REMARKS

FIGURE 1

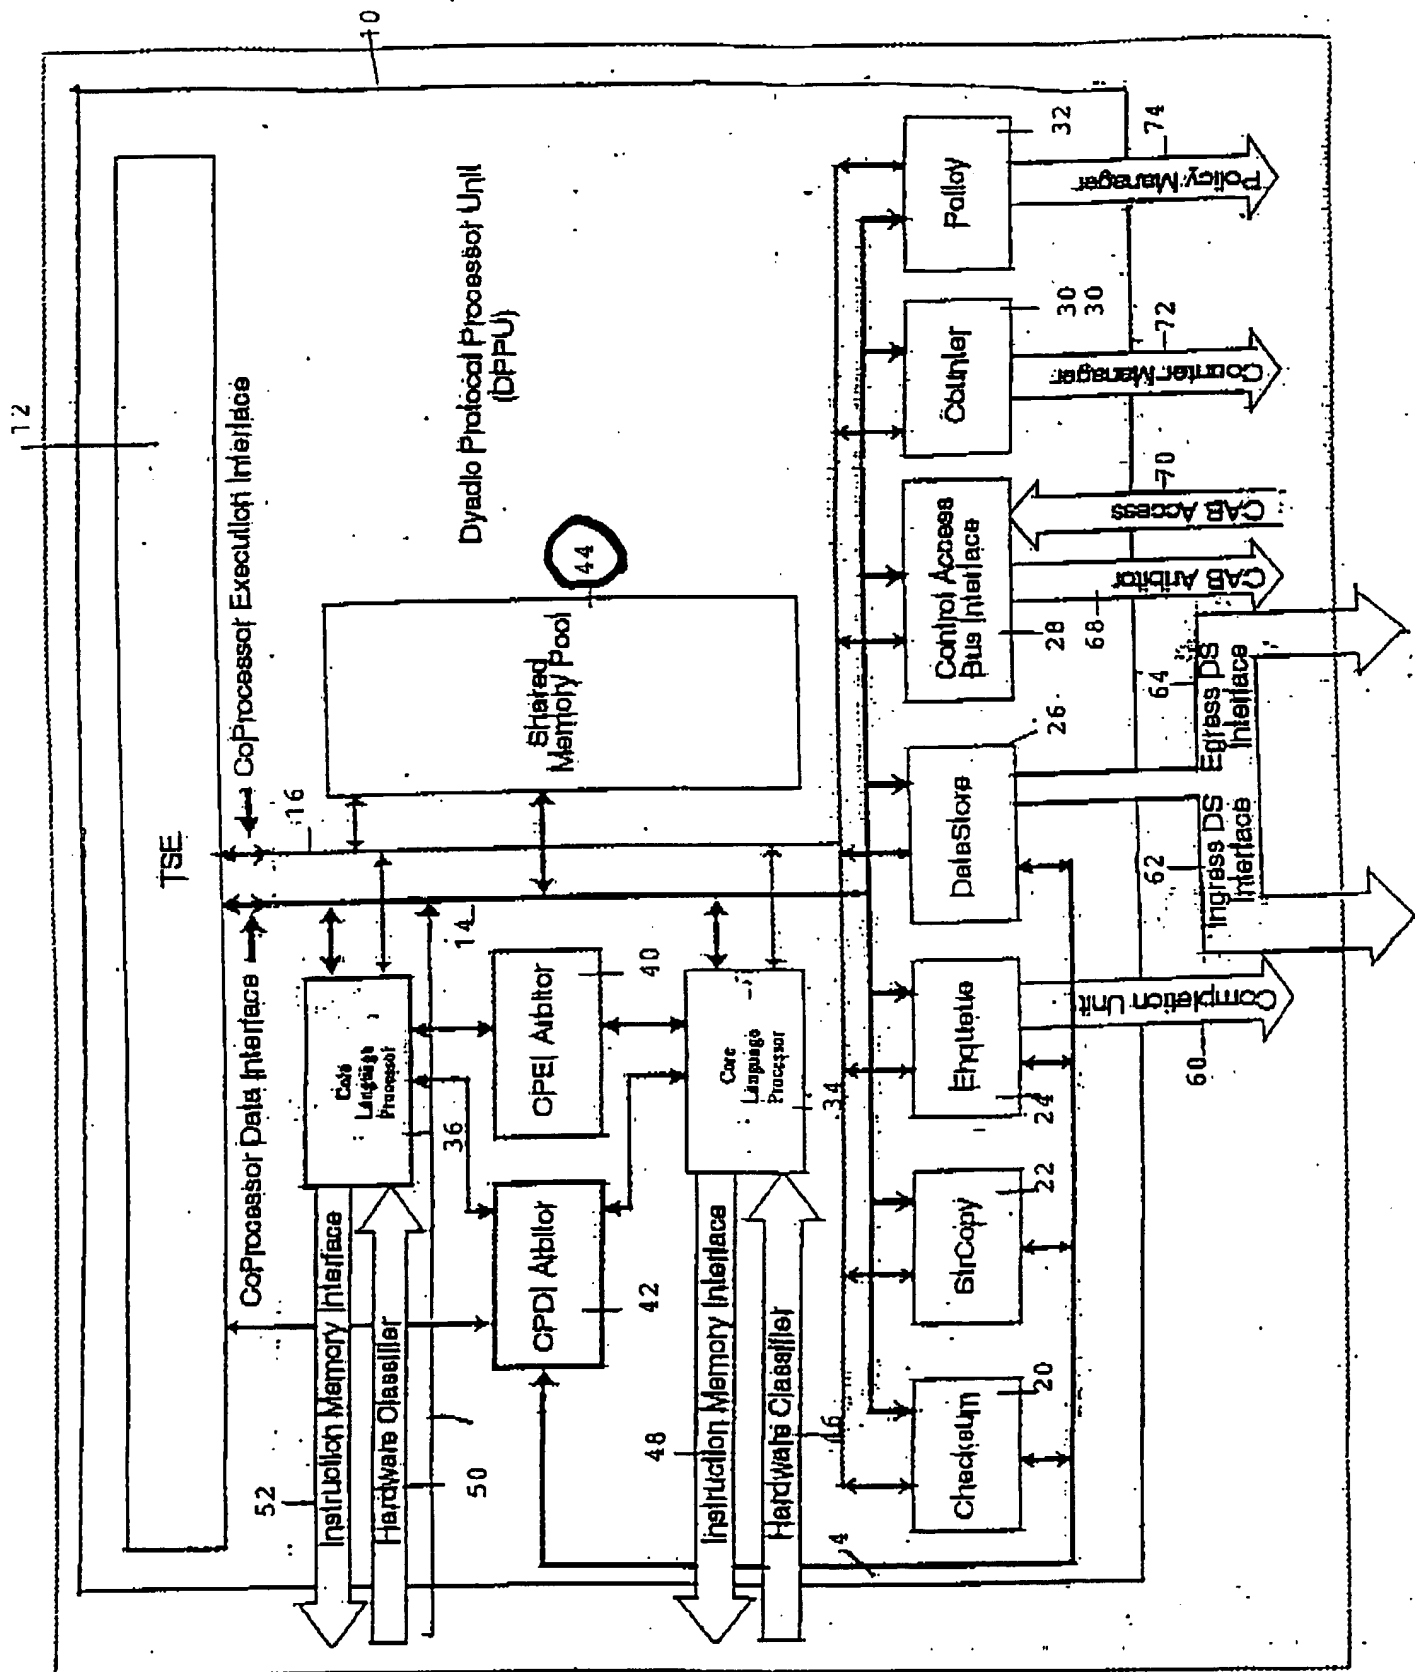
The drawings are objected to as failing to comply with 37 CFR 1.84(p)(5) because they do not include the following reference sign(s) mentioned in the description: 44 of fig 1, 80, 82, 84, 86, 88, 90, 92, 96, 98, 100, 102 of fig 3, 450 of fig. 4, 509, 510, 511, 521, of fig. 5. A proposed drawing correction or corrected drawings are required in reply to the Office action to avoid abandonment of the application. The objection to the drawings will not be held in abeyance.

Applicants respectfully respond to the objections to the drawings by calling the examiner's attention to the fact that most, if not all, of the numbers noted by the examiner are, in fact, included in the drawings. Thus, the numerals 44, 80, 82, 84, 86, 88, 90, 92, 96, 98, 100, 102, 509, 510, 511, 521 all appear in the drawings. Applicants herewith submit Sheets 1, 3 and 5 with the numbers circled for clarification. If there is a discrepancy between the figures herein submitted and the drawing sheets as filed, applicants respectfully request that the examiner advise the undersigned. Furthermore, page 19 has been amended to delete all references to the numeral 450 appearing thereon. The correct part number is 411, which is shown in Figure 4. Applicants respectfully submit that this action is dispositive of the drawing issue.
